**ORKNEY**  
ISLANDS COUNCIL

**Local Review Body: 13 December 2024.**

**Proposed Erection of Ten Houses with Air Source Heat Pumps and Associated Infrastructure near Cairston Road, Stromness (22/382/PP).**

**REQUEST FOR PLANNING REVIEW AGAINST THE TERMS OF CONDITION 7  
PLANNING PERMISSION 22/382/PP****ERECT 10 HOUSES WITH AIR SOURCE HEAT PUMPS, CONSTRUCT A ROAD AND ASSOCIATED  
LANDSCAPING AND INFRASTRUCTURE****CAIRSTON ROAD, STROMNESS, ORKNEY, KW16 3JS**

**Plan A – plan as approved with footway that extends to either side of the bellmouth of the new access.**

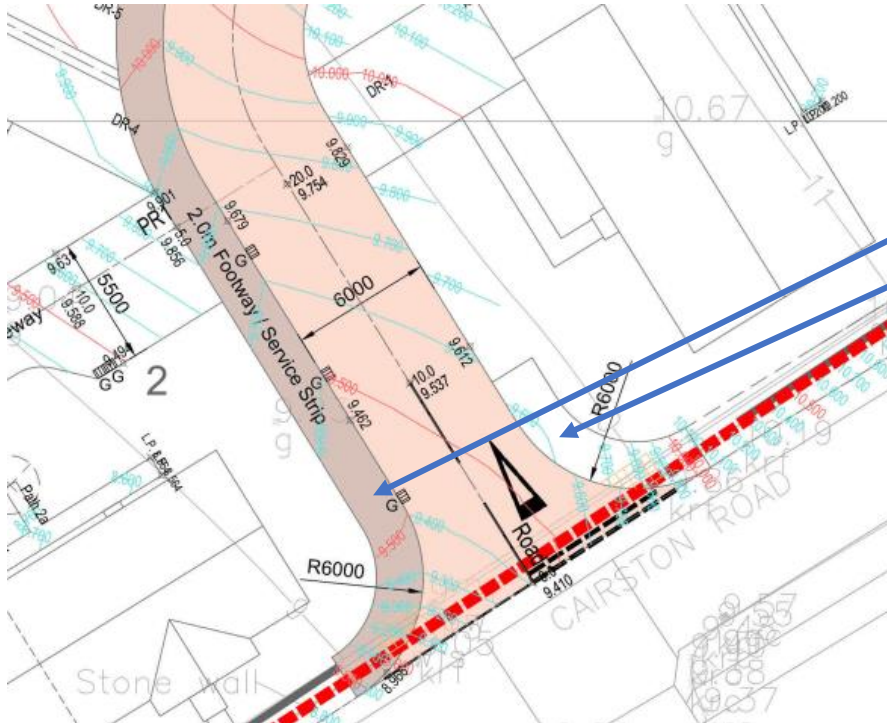
First and foremost, the terms of the condition exceed that of the requirements specified by the Roads Service. In their consultation memo dated 6 November 2023 (their final comment) they stated that they had no objections and supported the proposed layout including the access arrangements. The response did include a reference to the provision of a footpath and stated:

*However, it is noted that there has been no amendment made to the footpath from the development at its junction with Cairston Road, where it was previously requested that the sections of footway should be extended to provide pedestrian crossing points. However, this is something that could be achieved by an appropriate planning condition.*

To be clear, the proposed site layout indicated a footway that extended the length of the new access through the development site but had not extended the footway east to a point where safe pedestrian crossing points could be formed. The crossing point would provide safe access to the existing footway which extends both east up the hill and west to the town centre.

Firstly Plans A and B above are stamped as the approved plans pertaining to the planning permission. The condition contradicts the details of the approved plans.

**Plan B – APPROVED SITE LAYOUT PLAN with footpath crossing identified on the new access road (Red arrow)**

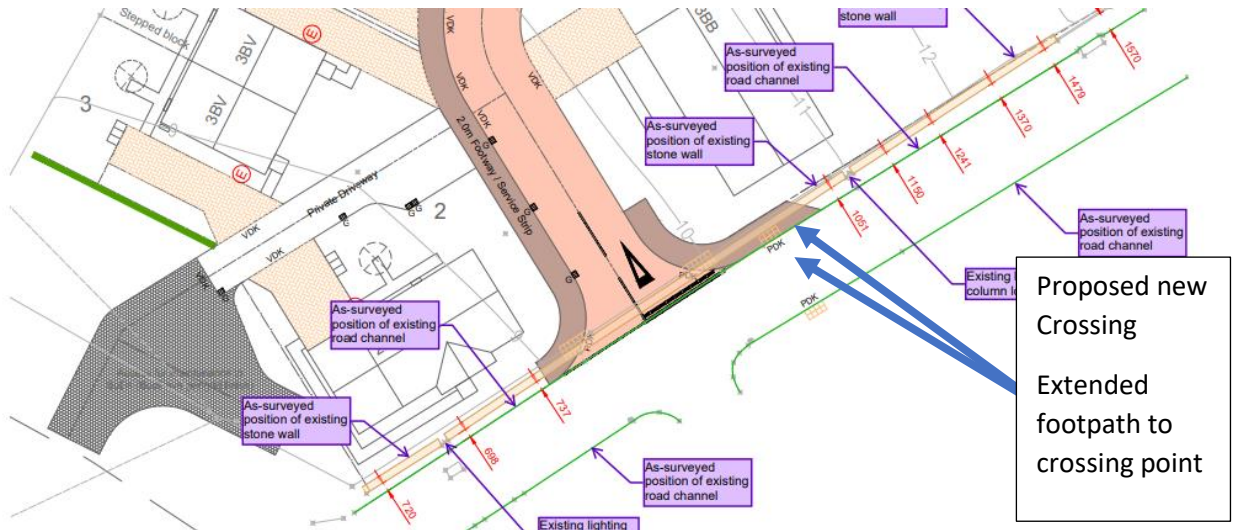
Plan C – details to address the terms of the Condition and comply with the Roads Service requirements and was submitted to the planning service on 24 July 2024 but has not been responded to. It provides an extended footway and pedestrian crossing to secure access to the existing footway on Cairston Road. Just as required by the Roads Service.

Secondly, Plan C was submitted to demonstrate that the terms of the Condition can be achieved but *in line with the requirements of the Roads Service – that is, extend the pavement to a safe (new) crossing point which in turn provides safe access to the existing footway on the opposite side of Cairston Road.*

The pedestrian-safe option is as shown on Plan C above: an extended footway that provides a pedestrian-safe crossing to the existing footway on the opposite side of the road.

The Cameron and Ross drawings (Plan C), demonstrate that a pedestrian crossing close to the site access will serve a direct purpose enabling pedestrians, pupils etc to cross the road close to the site entrance all as required by the Roads Service and set out in their consultation response.

For all these reasons, the condition should be deleted. For the avoidance of doubt the applicant has no difficulty in complying with the Roads Services requirement to provide an extended section of footpath and safe pedestrian crossing points to gain access to the existing footway. A condition to that effect would be acceptable to the applicant.
